**IN THE MATTER** of Private Plan Change 20: Titanium Park Limited and Rukuhia Properties Limited - Airport Northern Precinct Extension

**STATEMENT OF EVIDENCE OF VINISH ANAND PRAKASH**

**(TRANSPORT)**

**Dated 7 March 2023**

**Figure 4: Peacockes Road (southern section) cross section**

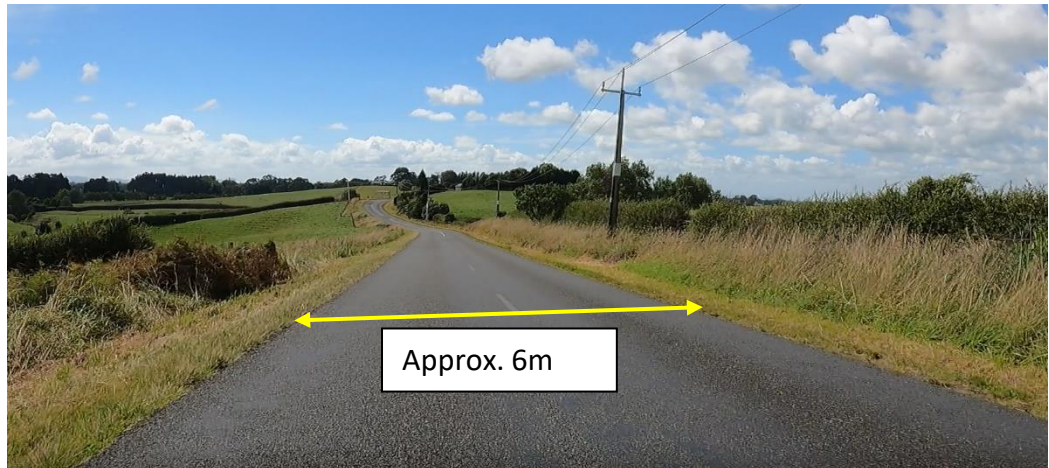
24. I disagree that Peacockes Road in its current state is appropriate for commuter cycling. There are no existing treatments for cyclists (i.e. separated cycle lane or shared path) on Peacockes Road. Cyclists that do wish to cycle will be required to cycle in the lane in a high speed environment that I consider to be unsafe due to the potential conflict speeds being higher than survivable conflict speeds (30km/h) for cyclists<sup>13</sup>.

25. Waka Kotahi's MegaMaps (Road to Zero Edition 1) identifies the land use on Peacockes Road as either Urban Residential or Urban Fringe. The southern section of Peacockes Road consists of a 6m wide carriageway and wide grass berms which range from 5-9.5m wide. The traffic volume on Peacockes Road is 658 veh/day<sup>14</sup> but it is likely to increase once the Waikato River Bridge project is completed as it is likely be an attractive

Figure 7: Peacocke Infrastructure<sup>18</sup>

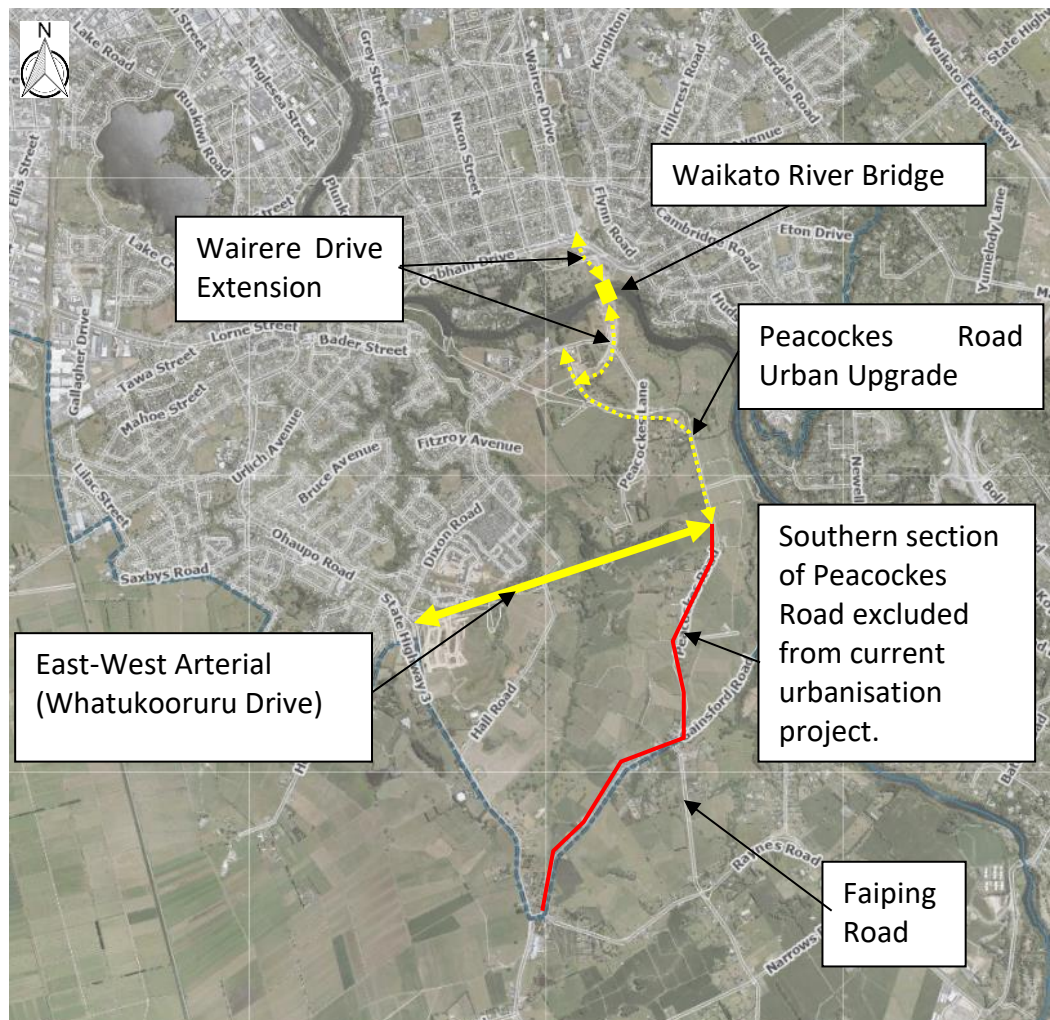
31. The northern section of Peacockes Road is currently being urbanised and the urbanisation is likely to be completed by the end of 2025. This upgrade includes separated cycle facilities on both sides of the road. The planned infrastructure upgrades for the northern section of Peacocke are summarised in Figure 7 below and shown on Figure 8 as yellow lines.

- 34. I recommend that the proposal is amended to ensure that an interim separated cycling connection is provided from the Northern Precinct to connect to the planned walking and cycling facility on Peacockes Road.
- 35. I consider that the walking and cycling transport upgrade provision included in the transport upgrades table in Rule 10.4.2.13A.7 be amended as follows (my proposed addition is underlined):

7.	<p><u>a.</u> Construction of new walking and cycling shared path connecting Peacocke Road to the Northern Precinct via Middle Road and Faiping Road or a suitable alternative.</p> <p><u>b.</u> Construction of a 2.5m wide shared path from Faiping Road to the existing separated walking and cycling facility at the intersection of Peacockes Road and <u>Whatukooruru Drive.</u></p>	<p>To be completed prior to:</p> <ul style="list-style-type: none"> <li>• Any section 224c certificate for subdivision under the RMA being issued for the completion of any subdivision within Northern Precinct; or</li> <li>• Any industrial / commercial activity being able to generate traffic.</li> </ul>
----	---	---

**Figure 9: Journey distance from Raynes Road access to Peacockes Town Centre**

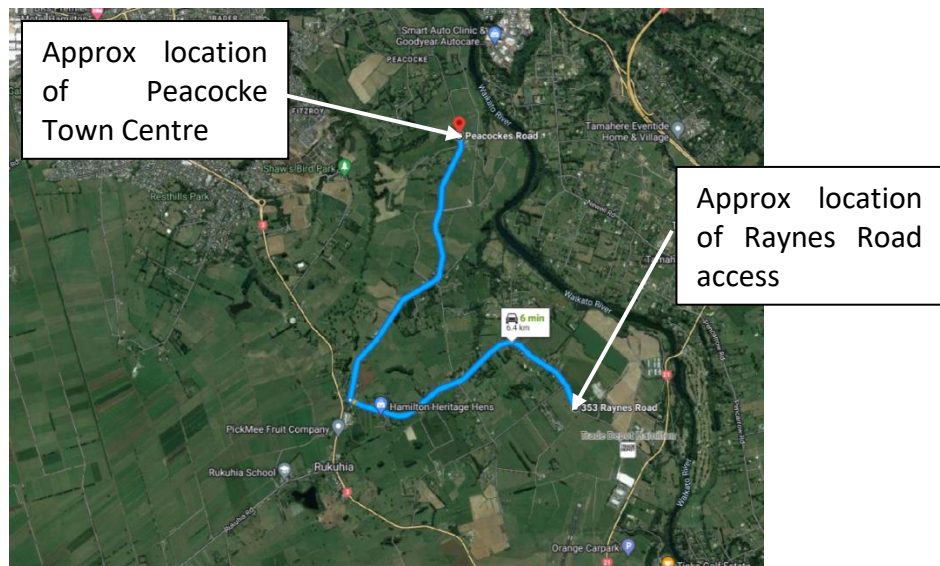
38. I have used Google Maps to determine the difference in travel distance to the Peacockes Town Centre from the two proposed accesses into the Northern Precinct. I have estimated the locations of the proposed access points.
39. Based on Google Maps if a vehicle were to travel to the Peacockes Road/Whatukooruru Drive intersection via the Raynes Road access, the journey length would be approximately 6.4km.

42. In my view the risk of drivers ignoring the regulatory signs is highest for those trips to/from the northern part of the plan change area. The risk of this occurring could be managed by requiring that the initial stages of development to only have access to SH 3 and that the Raynes Road access is only provided once Peacockes Road has been upgraded.

**Figure 10: Journey distance from SH 3 access to Peacockes Town Centre**

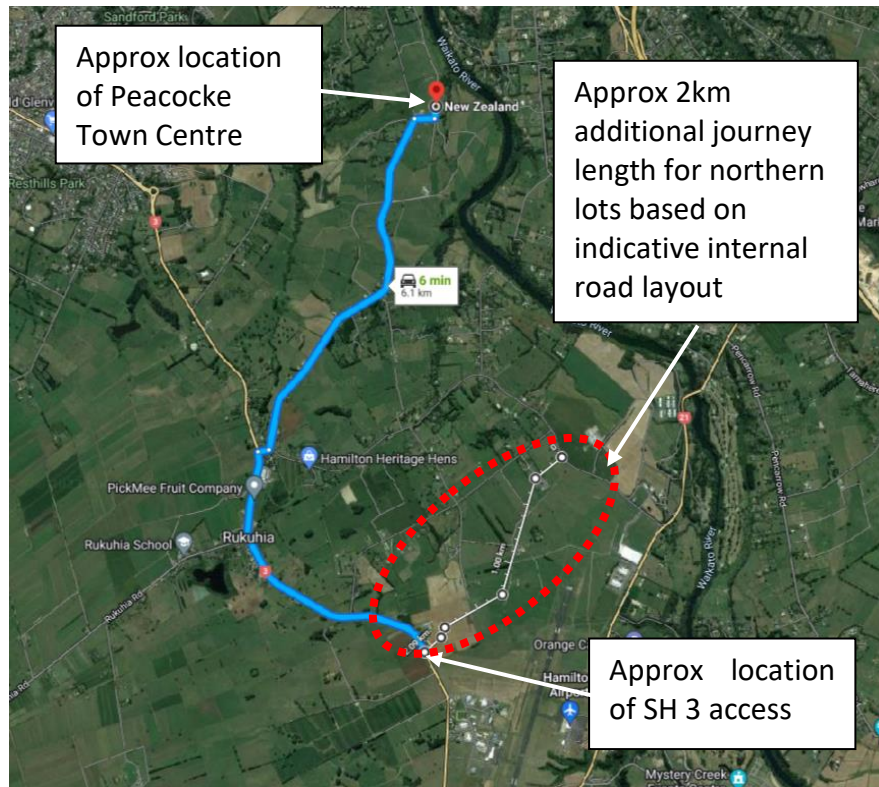
40. Based on Google Maps if a vehicle were to travel to the Peacockes Road/Whatukooruru Drive intersection via the SH 3 access, the journey length would be approximately 6.1km. However, commuters from the northern section of the Northern Precinct would need to commute up to an additional 2km through the Northern Precinct to get to the SH 3 access. Therefore, the total journey distance would be approximately 8.1 km.

41. Although the distance from the SH 3 access to Peacockes Road is shorter, the total journey length for commuters in the northern section will be up to 2km longer. I am concerned that the longer travel distance for northern lots, combined with commuter perception of greater delays on SH 3 will result in non-compliant use of the Raynes Road access and vehicles heading north via Peacockes Road. In my view there is a risk that this could result in unanticipated deterioration of network safety and capacity.

**Figure 12: Proposed dual northbound lanes at SH3/Raynes Road**

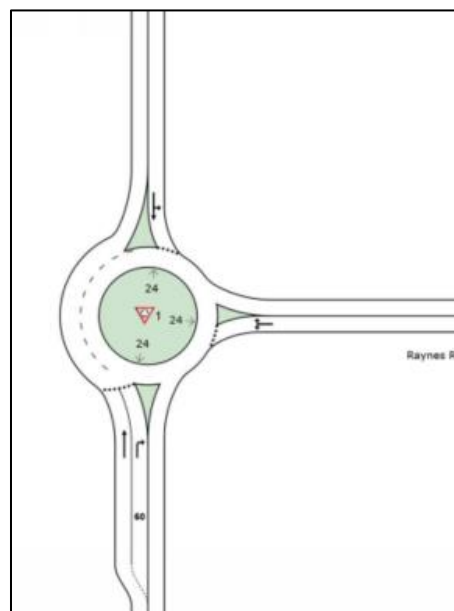
51. Section 2 of the modelling report prepared by BBO<sup>25</sup> states that “The roundabout design will most likely need to reflect the layout shown in Figure 5 to accommodate the future projected traffic flows at this intersection. This applies to Options 4 and 6 discussed in this memorandum”.
52. The figure that the statement in paragraph 51 above refers to is shown below. The arrangement includes dual northbound lanes at the roundabout.

54. Waka Kotahi has engaged Gray Matter Ltd to design the SH3/Raynes Road roundabout as part of a Speed and Infrastructure Programme (SIP) project and the current design is a single lane roundabout. I understand that there are constraints that may restrict future construction of dual lanes on the northbound SH 3 approach. I understand that the Applicant is entering into a private development agreement with Waka Kotahi for these works. I consider this to be the most appropriate way to provide dual lanes on the SH3 northbound approach.

**Figure 13: Future Raynes Access Stub Leg**

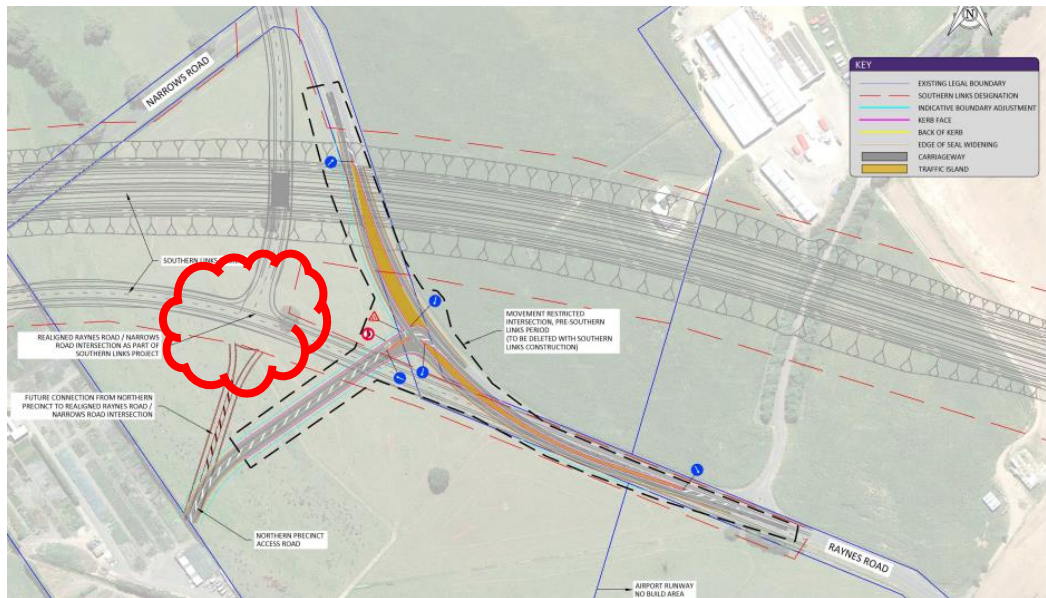
84. I was concerned that the future layout of the realigned Narrows Road /Raynes Road/Raynes Road Access intersection has not been confirmed. Drawing 144380\_06\_0031 in Attachment 1 of Mr Inder's evidence indicates a stub leg with no intersection shown on the realigned Raynes Road. Upon further review of the available information, I consider that the intersection form will be best determined during detailed design of the Southern Links project by Waka Kotahi.
